DART AEROSPACE LTD	Work Order: 93999
Description: Crosstube Assembly (412 High Aft)	Part Number: D412-664-243
Inspection Dwg: D412-664-243 Rev: E	Page 1 of 2

DRAWING NO. D412-664-243	TITLE CROSSTUBE ASSEMBLY (412 HI AFT)	REV. E	DART AEROSPACE LTD ENGINEERING ORDER		D.E.O. NO. D412-664-243-E-1	SHEET NO. SHEET 1 OF 2	SCALE NTS
DRAWN	CHECKED	MFG. APPR.	APPROVED	DE APPR.			
DATE 11.03.31	DATE 11/03/31	DATE 11.03.31	DATE 11/03/31	DATE 11.03.31

DRAWING NO. D412-664-243	TITLE CROSSTUBE ASS'Y (412 HI AFT)	REV. E	DART AEROSPACE LTD ENGINEERING ORDER		D.E.O. NO. D412-664-243-E-2	SHEET NO. SHEET 1 OF 1	SCALE NTS
DRAWN 92	CHECKED ASS	MFG. APPR. RE	APPROVED MP		DE APPR. H		
DATE 11.09.07	DATE 11.09.19	DATE 11.09.19	DATE 11.09.19		DATE 11.09.19

DRAWING NO. D412-664-243	TITLE CROSSTUBE ASSEMBLY (412 HI AFT)	REV. E	DART AEROSPACE LTD ENGINEERING ORDER		D.E.O. NO. D412-664-243-E-4	SHEET NO. SHEET 1 OF 3	SCALE NTS
DRAWN 9	CHECKED A	MFG. APPR. A	APPROVED MP		DE APPR. MP		
DATE 12.08.21	DATE 12.08.30	DATE 12.08.30	DATE 12/8/30		DATE 12.08.30

**D412-664-243
ASSEMBLY DETAIL**

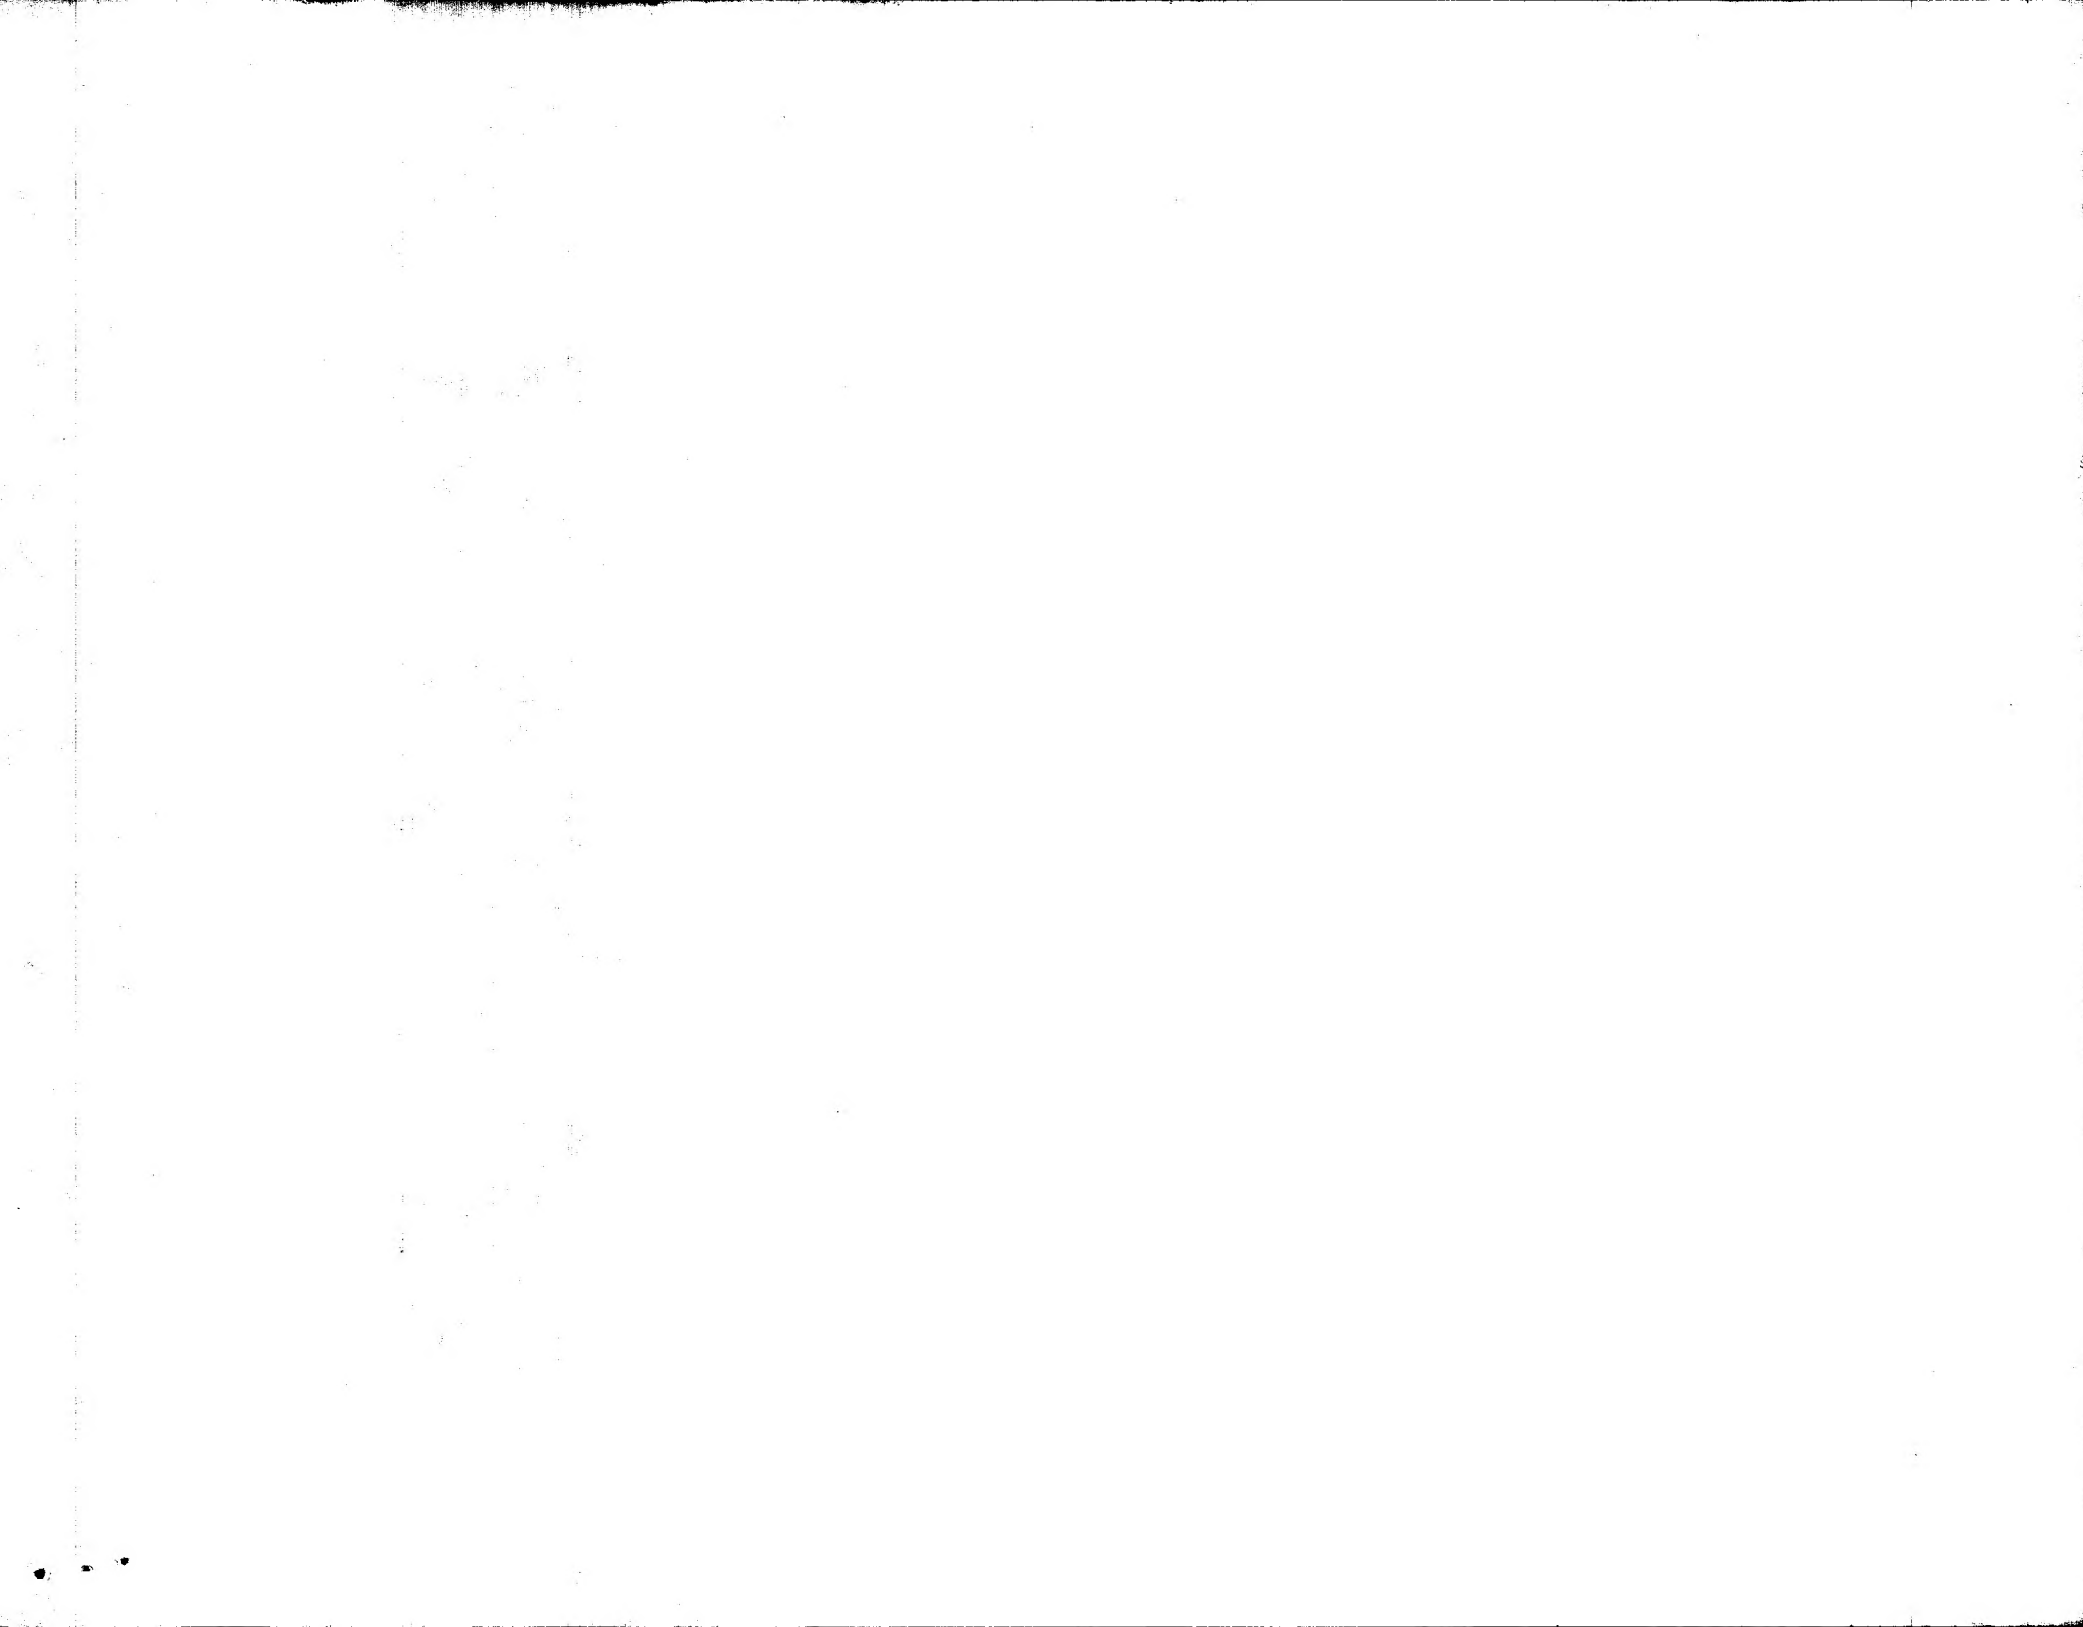
REMOVED ABRASION STRIP IN FAVOR OF A THIN LAYER OF PROSEAL 890. UPDATE INSTALLATION OF CHAFING SHIELDS AND REDUCE TORQUE TO 40-50 IN-LBS. THIS ENGINEERING ORDER SUPERCEDES DEO D412-664-243-E-1.

IS:

16 14
D3189-1 CHAFING SHIELD (1, INSTALLED OVER PROSEAL 890)
MS21920-28 CLAMP, 2X
2 PL

4.00
CLAMP SPACING
4.38
CHAFING SHIELD, REF

WAS:

14 16
D2856-600-1009 ABRASION STRIP
D3189-1 CHAFING SHIELD (1, INSTALLED OVER ABRASION STRIP)
MS21920-28 CLAMP, 2X
2 PL

2
MASK AREA PRIOR TO PAINTING AND
APPLY CLEAR COAT AFTER PAINTING

SECTION A-A
CHAFING SHIELD DETAIL
VIEW ROTATED, NOT TO SCALE

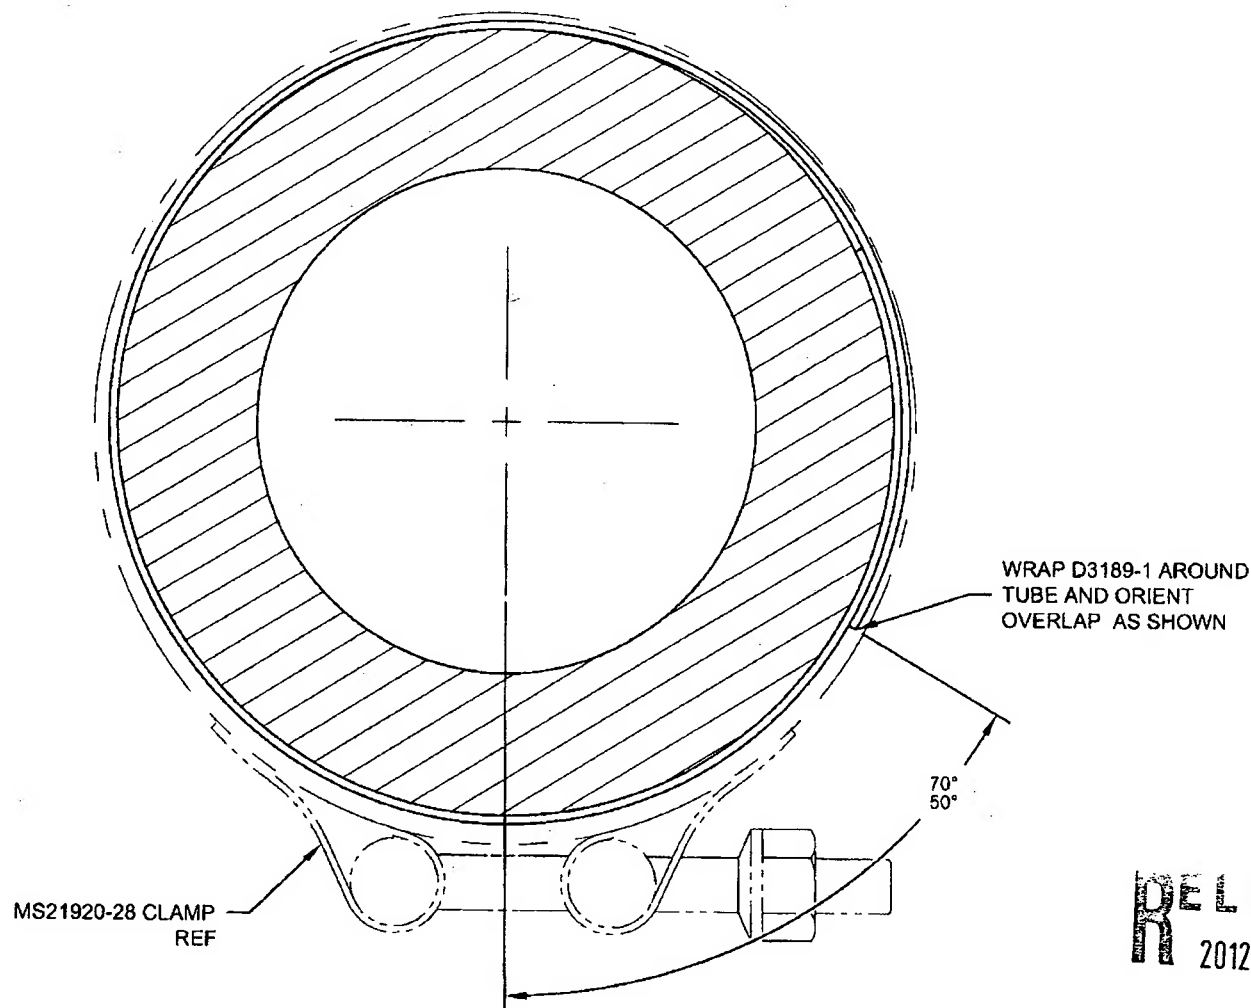
- 2) FINISH: CHEMICAL CONVERSION COAT PER DART QSI 005 4.1
PRIME INSIDE AND OUTSIDE PER DART QSI 005 4.2
MASK UNDERSIDE OF CROSSTUBE AS SHOWN (HATCHED AREA)
PAINT OUTSIDE PER DART QSI 005 4.2
AFTER PAINTING, APPLY CLEAR COAT ON HATCHED AREA
- 14) APPLY A THIN COAT OF PROSEAL 890 ON INSIDE CONCAVE SURFACE OF D3189-1 CHAFING SHIELD AND LET CURE PER MANUFACTURER'S INSTRUCTIONS. INSTALL PROSEALED D3189-1 CHAFING SHIELD ONTO CROSSTUBE BY APPLYING A THIN COAT OF PROSEAL 890 ONTO CROSSTUBE. BE SURE TO ELIMINATE ANY AIR GAPS.
- 16) TORQUE CLAMPS ON D2896-1 SUPPORT 80 TO 100 IN-LB. **TORQUE CLAMPS ON D3189-1 CHAFING SHIELD 40 TO 50 IN-LB.** ENSURE AT LEAST 1.5 THREADS SHOWING IN SAFETY AND THAT NUT HAS NOT BOTTOMED-OUT AFTER TORQUING.
